## Memorandum

Date: 2-14-08  
To: Rochester Hills BRA  
CC: E. Anzek, D. Delacourt  
From: Jim Anderson, STS  
Subject: Summary of Hamlin & Adams Properties Brownfield Redevelopment

**SITE MAP WITH PROPOSED SOIL BORING AND MONITORING WELL LOCATIONS**

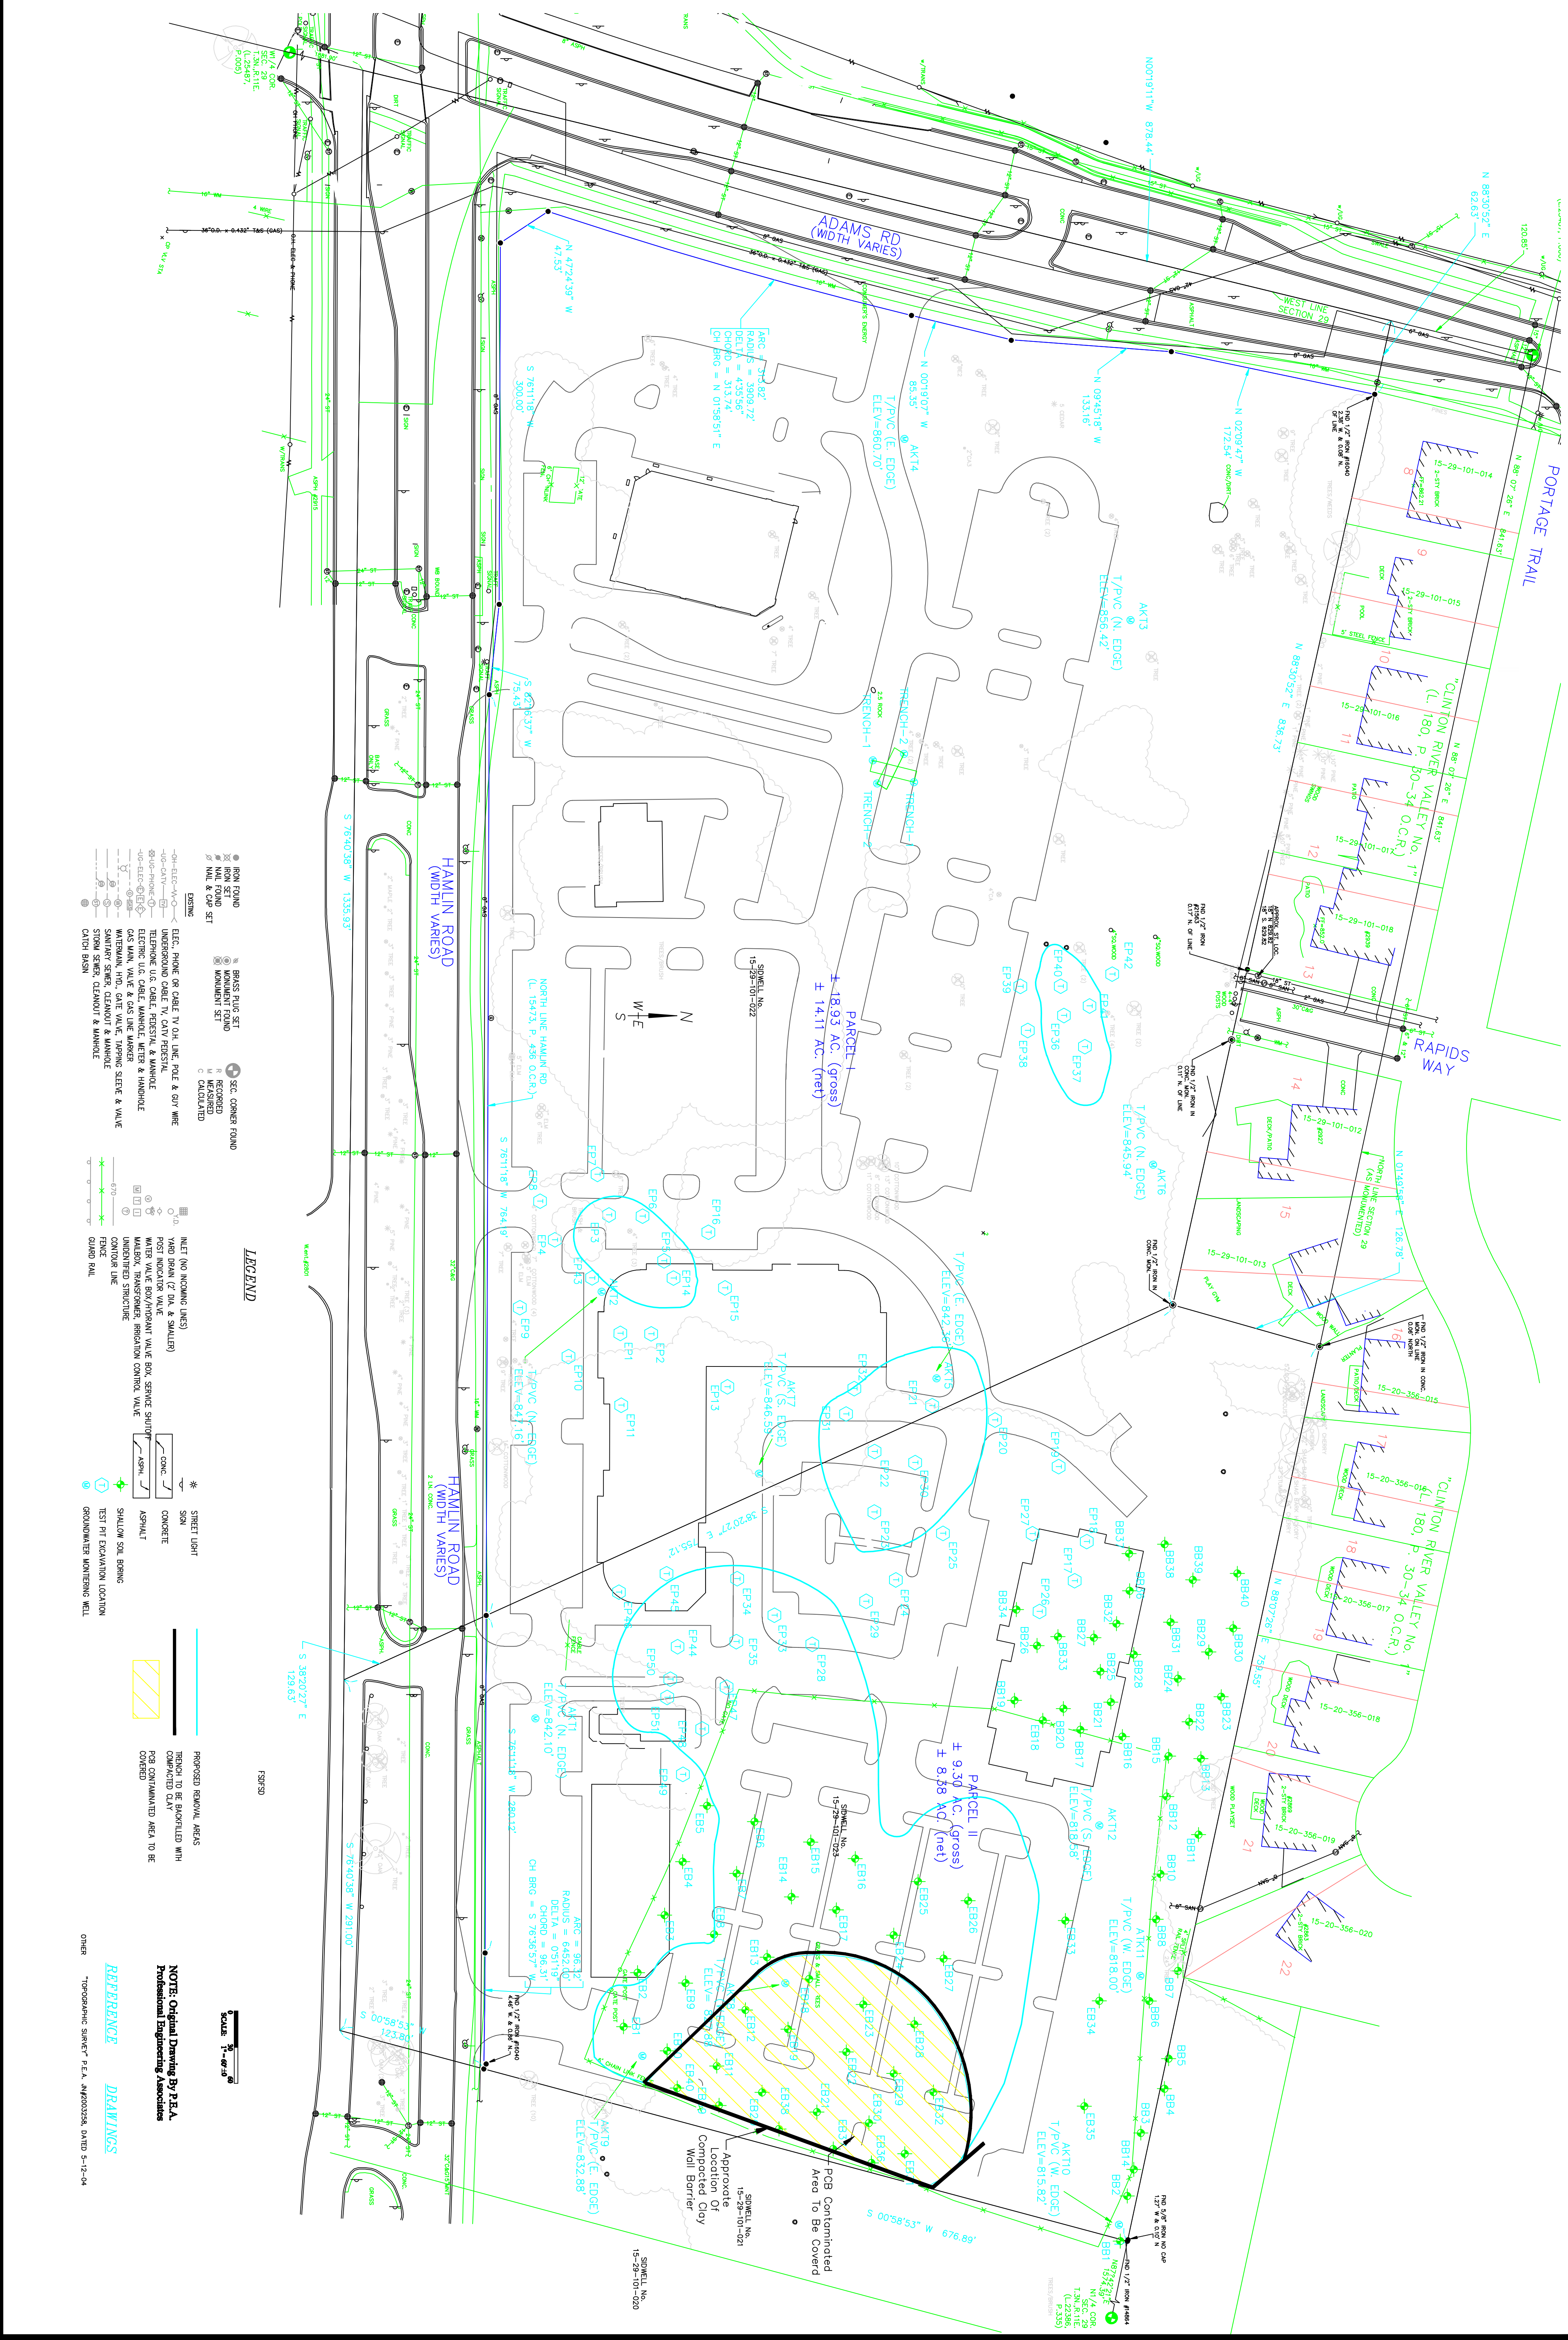
According to AKT Peerless, the following areas on the site warranted additional investigation (a figure is included for your reference):

- Area A; area of uncharacterized buried waste/debris material in the north central portion of the property.
- Area B; Area of PCB impacted surface soils in the northern portion of the eastern parcel.
- Area C; Area of uncharacterized buried waste/debris/drum material in the western portion of the east parcel and east portion of the west parcel.
- Area D; uncharacterized buried waste/debris/drum material in the south central portion of the property.

- Area E; Fenced-in area in the east parcel previously identified as containing drums and soils impacted with poly chlorinated biphenyls (PCBs) and volatile organic compounds (VOCs).
- Area F; Potential heating fuel use near a former structure (presumably the former slaughterhouse).
- Entire subject property to evaluate the potential presence of methane gas due to off-site migration of methane gas from the adjoining Suburban Softball/former Cardinal Landfill site.
